Public Service Commission

June 13, 2019

The North Dakota Public Service Commission (Commission) has reviewed your filing, dated May 15, 2019, regarding your land located in the NW $\frac{1}{4}$ of Section 34, T146N, R88W.

Your property is located off-permit and adjacent to Surface Coal Mining Permit NACT-9501 at the Coteau Properties Freedom Mine. The E $\frac{1}{2}$ of Section 34 is part of Surface Coal Mining Permit NACT-9501. Portions of the permitted area in the E $\frac{1}{2}$ of Section 34 were mined and reclaimed. Sedimentation ponds P-H34-04 and P-H34-05 were also constructed in the NE $\frac{1}{4}$ of Section 34 upstream of your property in 1999 and 2004, respectively. The purpose of sedimentation ponds is to detain surface runoff from mine disturbance areas until it meets the required effluent or discharge standards. During active mining operations, Coteau routed discharges from these ponds around your property through pipes to the main drainage channel in the NW $\frac{1}{4}$ of Section 34. Sedimentation pond P-H34-04 was removed and reclaimed in 2013 and sedimentation pond P-H34-05 was removed and reclaimed in 2015.

PostMine Topography, Landuse and Imagery above NW1/4 34, T146N, R88W

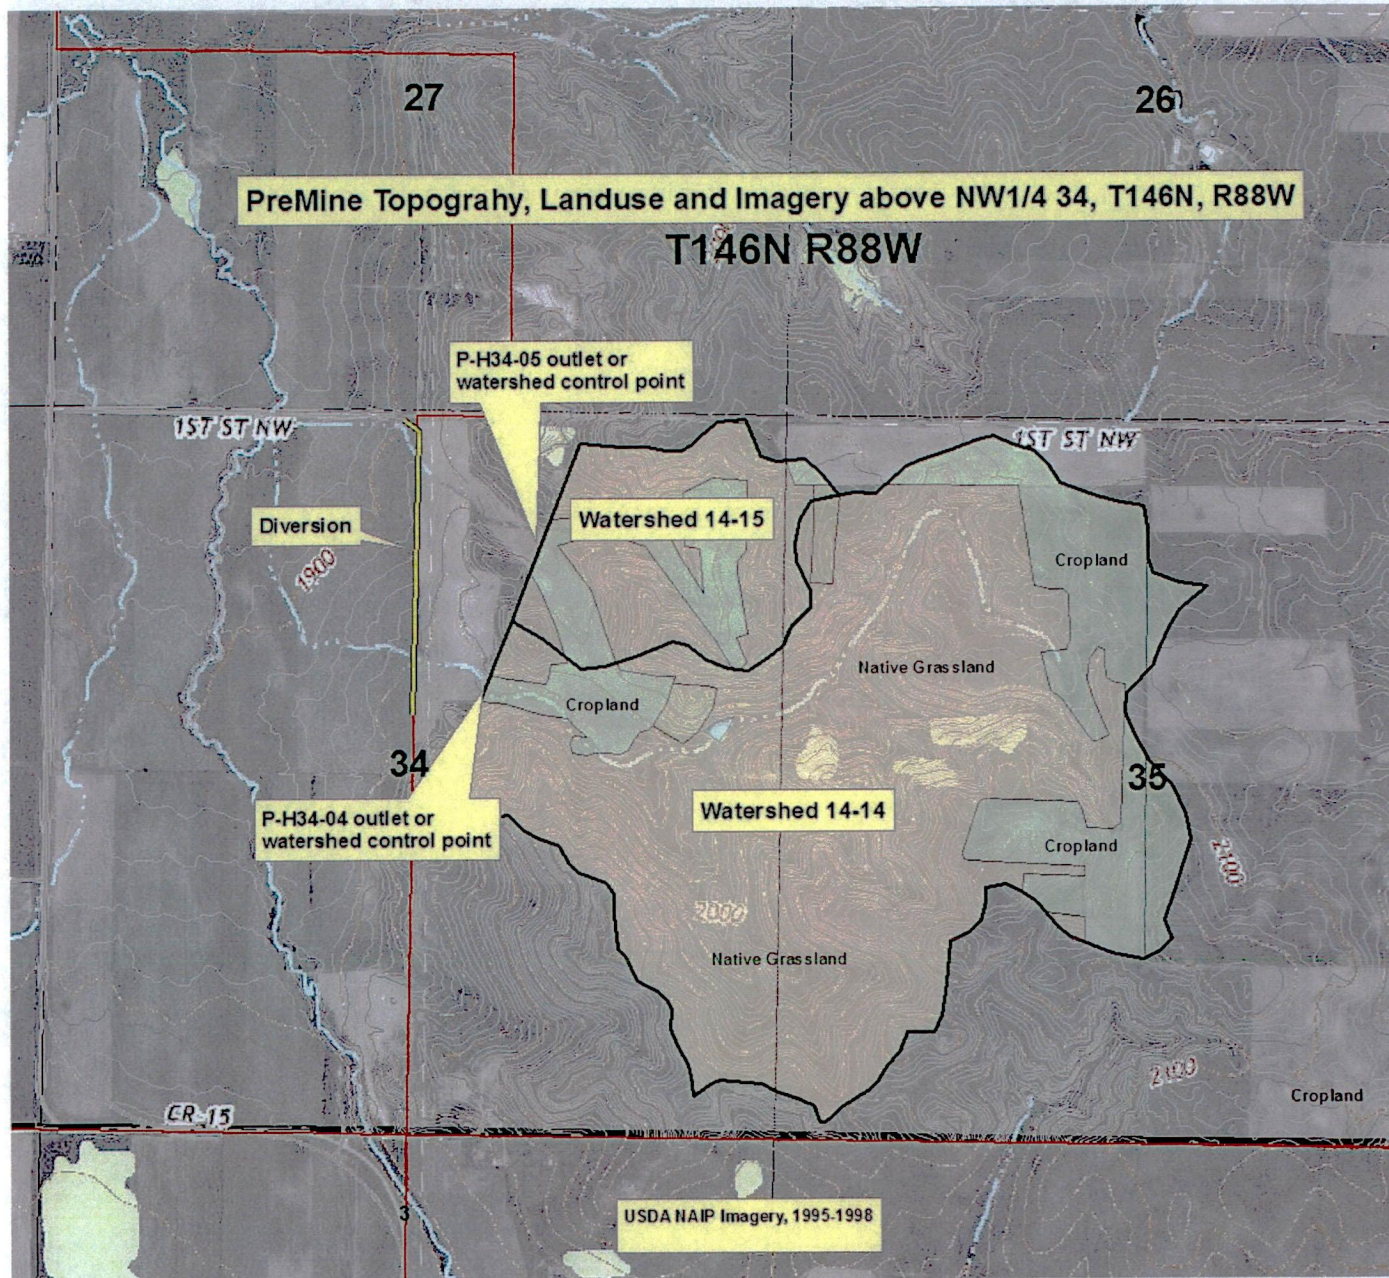
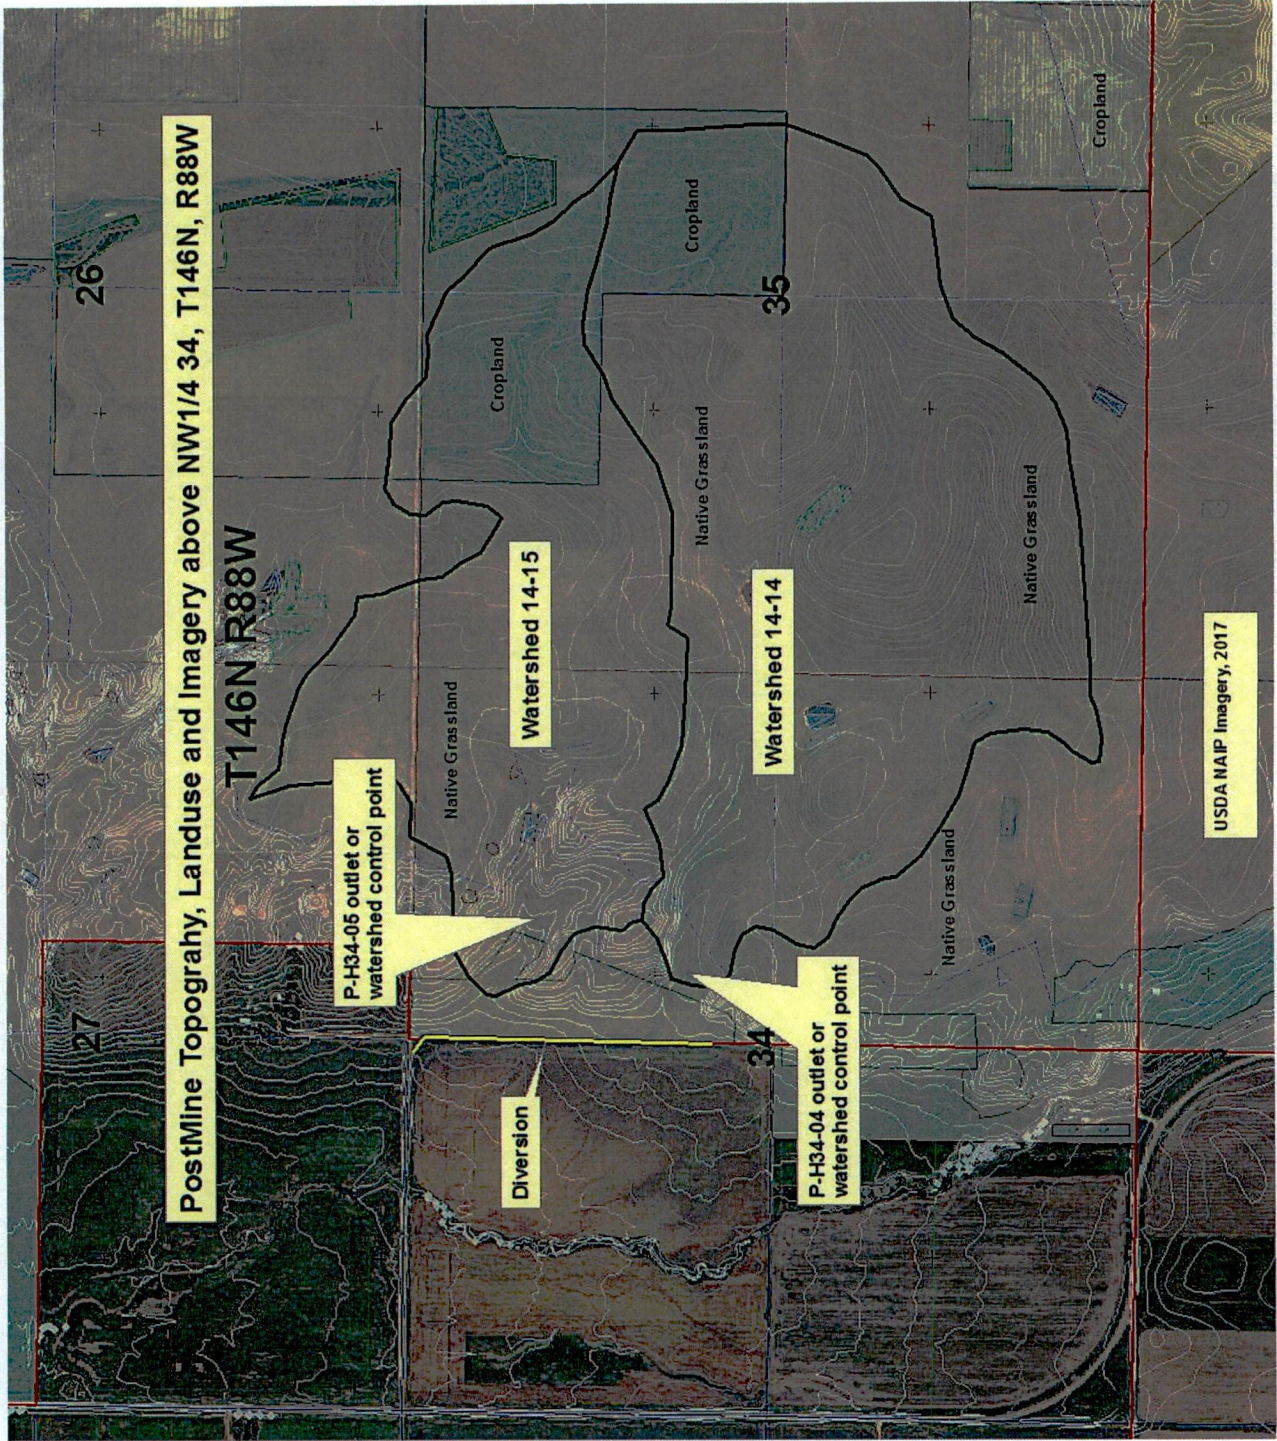
The Reclamation Division staff have reviewed the flow modeling provided by Coteau and have determined the parameters and assumptions used were appropriate and reflected the actual conditions. In response to your concerns, staff again modeled both watersheds and the results of our independent modeling are similar to those provided by Coteau in Revision 30. A copy of our analysis is attached.

Our analysis shows that even though the total combined watershed size increased after reclamation, the expected total flow rates and volumes are less than the premine condition. This is due to a number of reasons but is primarily due to the reclaimed or postmine watersheds being less steep than the premine watersheds. The premine average slope of watershed 14-15 was 12.7% and the postmine average slope is 4.4%. In addition, the shallow and claypan soils that were common in the premine watershed were replaced with deeper, loamy soils with higher infiltration rates. In addition, there is less cropland and more native grassland in the reclaimed watershed than in the premine watershed. The perennial native grassland vegetation generally has a lower runoff potential than cropland.

COTEAU <small>THE COTEAU MINING COMPANY</small>	FREEDOM MINE BEULAH, ND 58523
	FIGURE 1 AERIAL PHOTO 1977
SCALE: 1"=400' PROJECT:	PAPER SIZE 11"x17" REVISION:

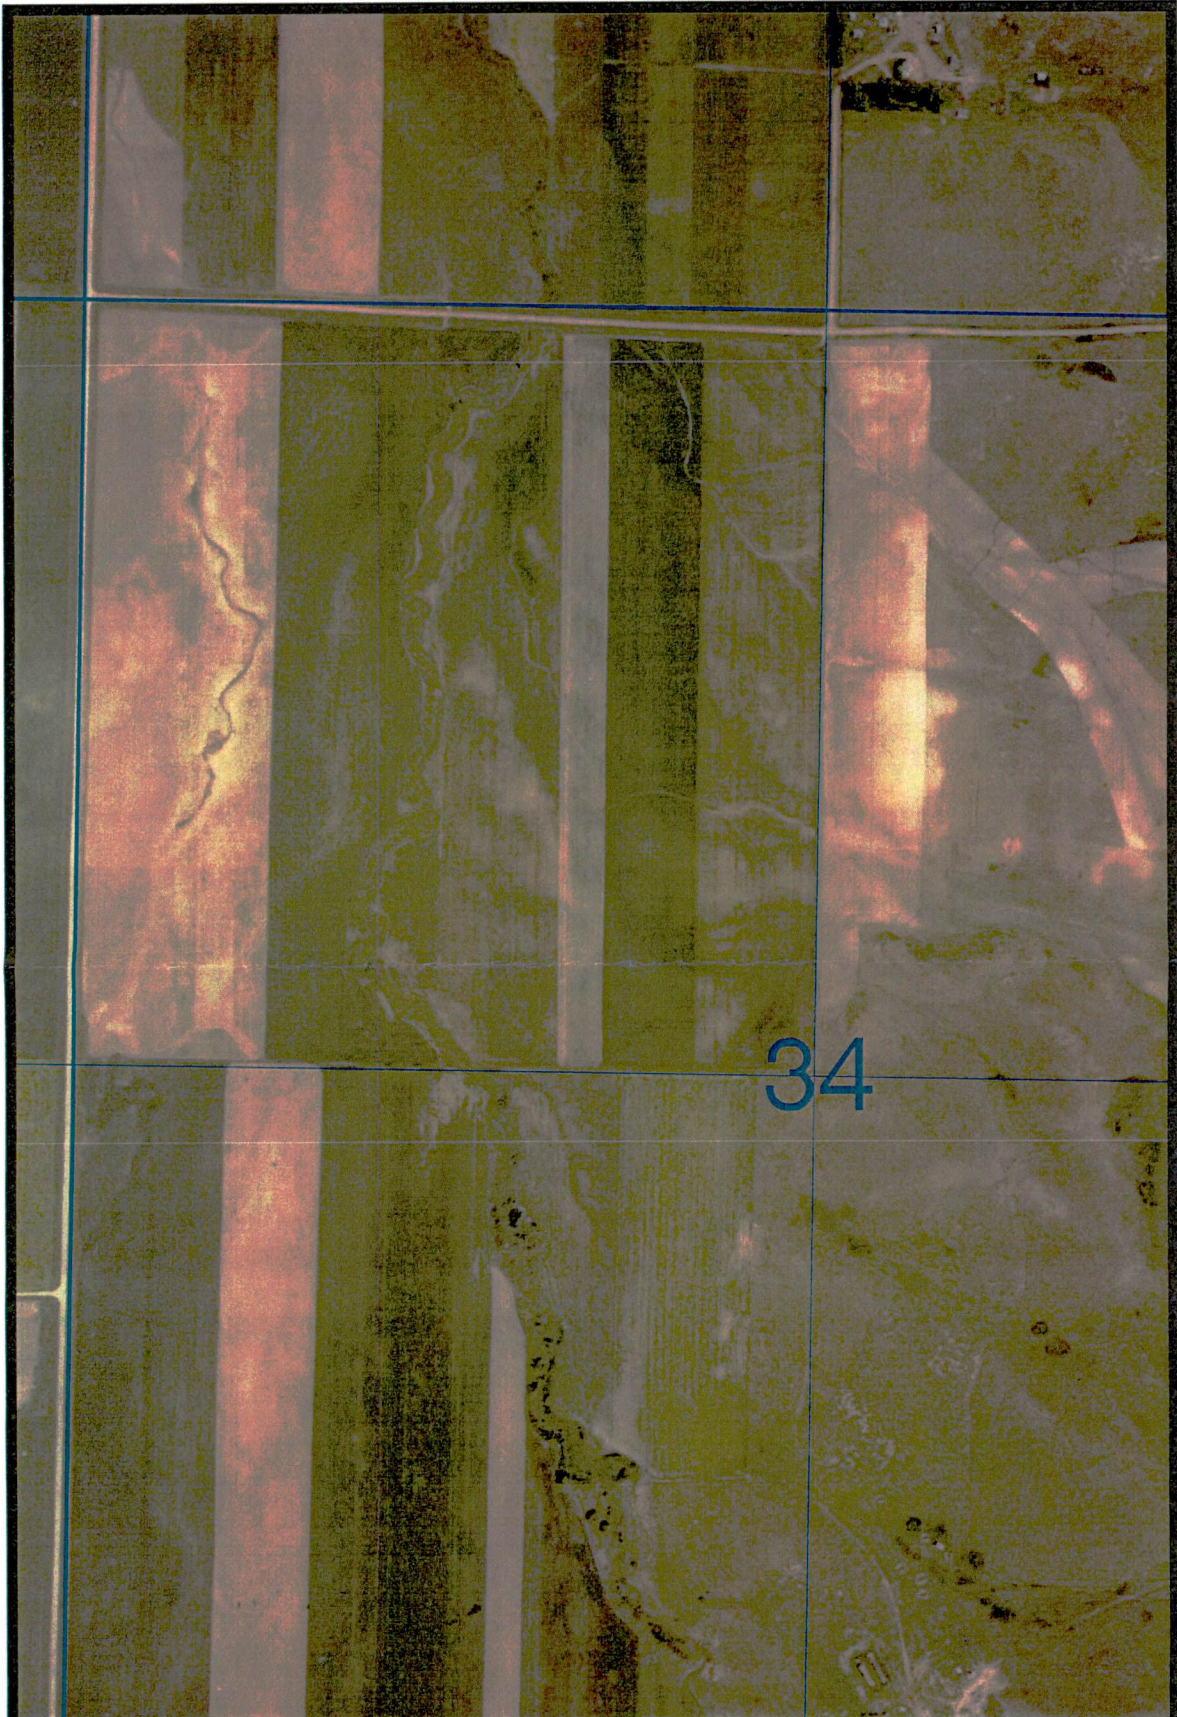
The diversion was not capable of handling pre-mining flows. This is evident by the erosion shown in Figures 1 and 2, attached. Figures 1 and 2 are aerial photographs of the field from 1977 and 1996 respectively.

FIGURE 3
 ORIGINAL SURVEY EISENBEIS DIVERSION
 NOVEMBER 29 2011

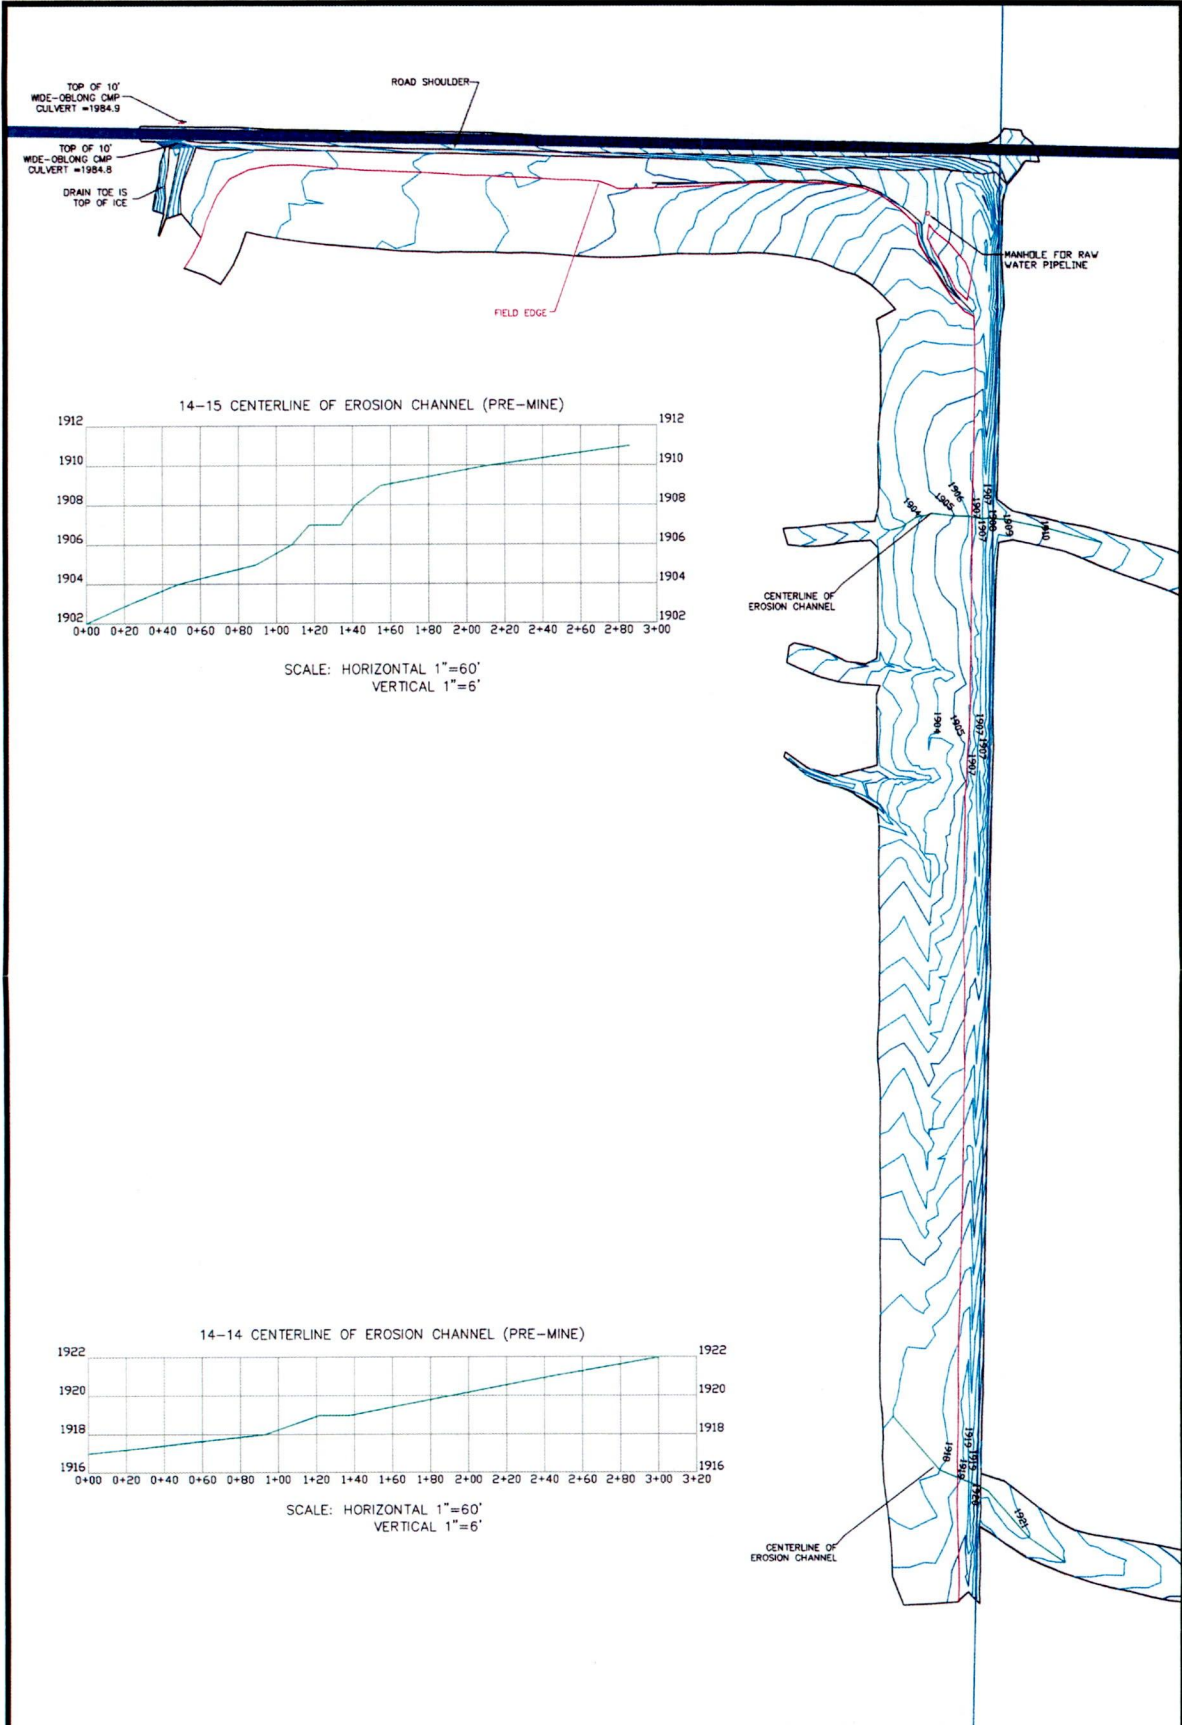
The producer approached Coteau in both 2010 and 2011 about aiding in repairing erosion in the field while the sediment ponds were in place and functioning. Additionally, Figure 3 is the original ground topography survey prior to reconstruction of the diversion. As can be seen in the drawing, there are several areas that show erosion west or below the diversion. Figure 3 includes two cross-sections of the existing diversion, one at the entrance of watershed 14-14 and one at the entrance of watershed 14-15. Both cross-sections indicate that runoff would flow across the diversion to the west uninterrupted. This survey was collected on November 29, 2011, after installation of the sedimentation ponds, but prior to the reconstruction of the diversion or removal of any sedimentation ponds.
